## Modifications to plant feed board

These file contain instructions for bodging plant feed board.

1. For sw serial port that connects to IMU sensor

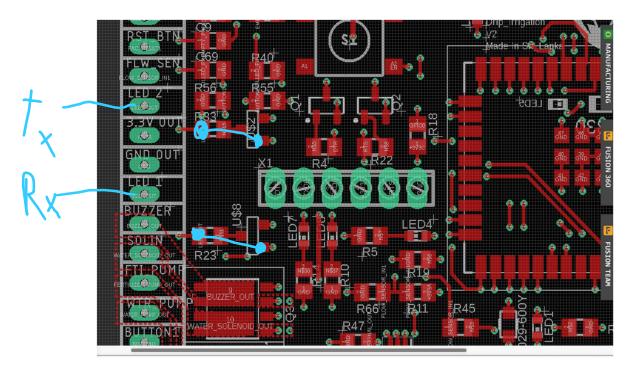
Remove resistor and transistor on the bodging pads shown below if they are populated. Connect a wire as shown below.
